# Reliability Analysis Update PJM West

Wenzheng Qiu  
Sub Regional RTEP Committee – PJM  
West

# AEP Transmission Zone: Baseline B3333 Cancellation

## B3333: Presented in 8/10/2021, 8/31/2021

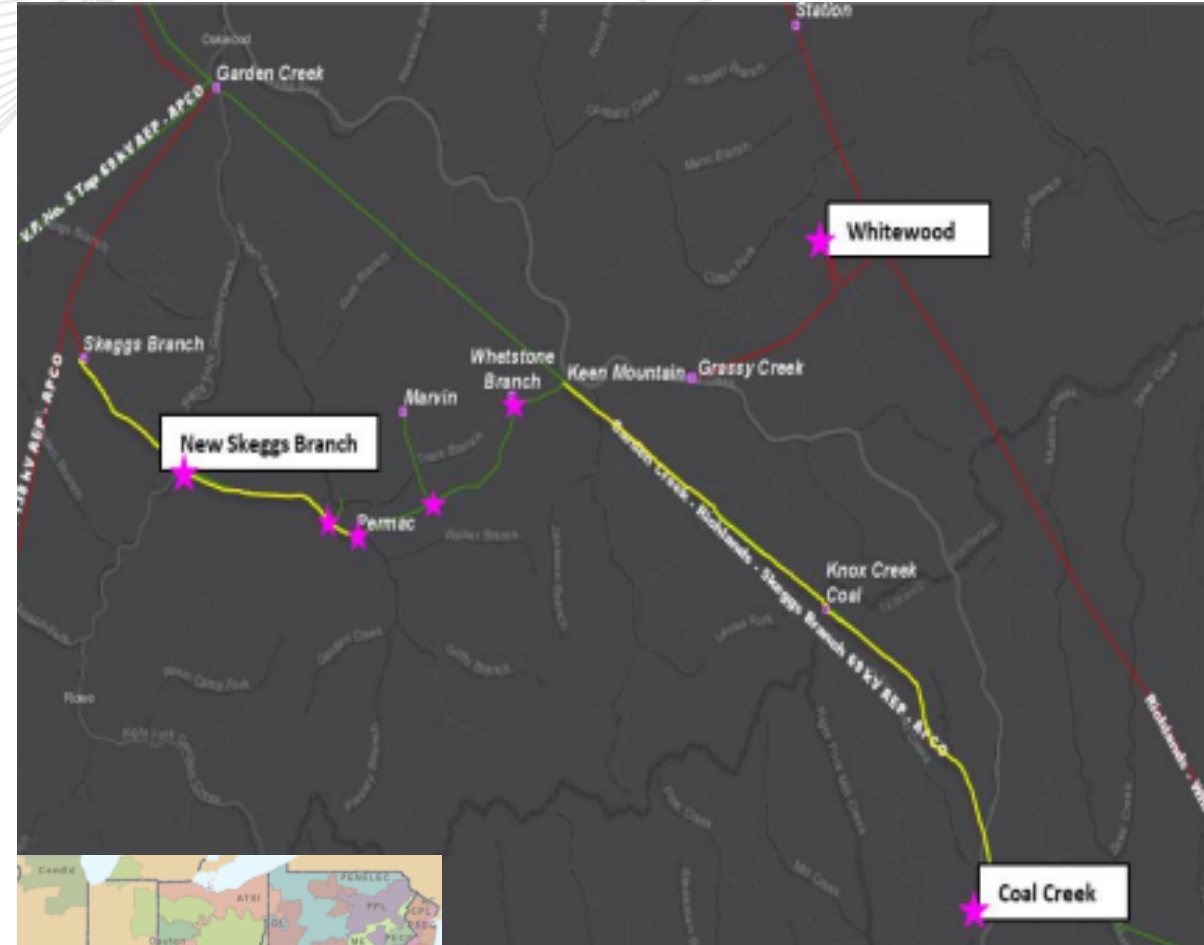
**Original Driver:** AEP Buchanan units 1 and 2 Deactivation

- Rebuild Skeggs Branch substation in the clear as Coronado substation Establish New 138kV and 69kV Buses. Install 138/69kV 130 MVA transformer, 138kV Circuit Switcher, 69kV breaker. Retire Existing Skeggs Branch substation (B3333.1) \$ 6.315 M

- New ~1.2 mi 138kV extension to new Skeggs Branch substation location. (B3333.2) \$ 4.62 M
- Install 46.1 MVAR Cap bank at Whitewood substation along with a 138kV breaker. (B3333.3) \$ 1.05 M

- Rebuild ~9 mi 69kV line from new Skeggs branch station to Coal Creek 69kV line. 6-wire the short double circuit section between Whetstone Branch and Str. 340-28 to convert the line to single circuit. Retire Garden Creek to Whetstone Branch 69kV line section. (B3333.4) \$ 26.25 M

- Retire Knox Creek SS. (B3333.5) \$ 0.06 M • Retire Horn Mountain SS. This will be served directly from 69kV bus at New Skeggs branch Substation. (B3333.6) \$ 0.05 M

- At Clell SS, Replace (2) 600A POP Switches and Poles with single 2 Way 1200A POP Switch and Pole. (B3333.7) \$ 0.34 M
- At Permac, Replace 600A Switch and structure with 2 Way 1200A POP Pole Switch and pole. (B3333.8) \$ 0.31 M

- At Marvin SS, Replace 600A Switch and structure with 2 Way 1200A POP Pole Switch and pole. (B3333.9) \$ 0.31 M
- At Whetstone Branch substation, Replace 69KV 600A 2 Way POP Switch with 69KV 1200A 2 Way POP Switch. Remove 69KV to Skeggs Branch (Switch "22" POP). (B3333.10) \$ 0.568 M

- At Garden Creek substation, Remove 69KV Richlands (via Coal Creek) line (Circuit Breaker F and disconnect switches) and update relay settings. (B3333.11) \$ 0.138 M
- Remote End work at Clinch River substation. (B3333.12) \$0.08 M
- Remote End work at Clinchfield substation. (B3333.13) \$0.08 M

- AEP Buchanan units 1 and 2 deactivation is withdrawn
- No reliability issue identified in PJM's DNH study with the cancellation
- Supplemental needs will be addressed through supplemental process
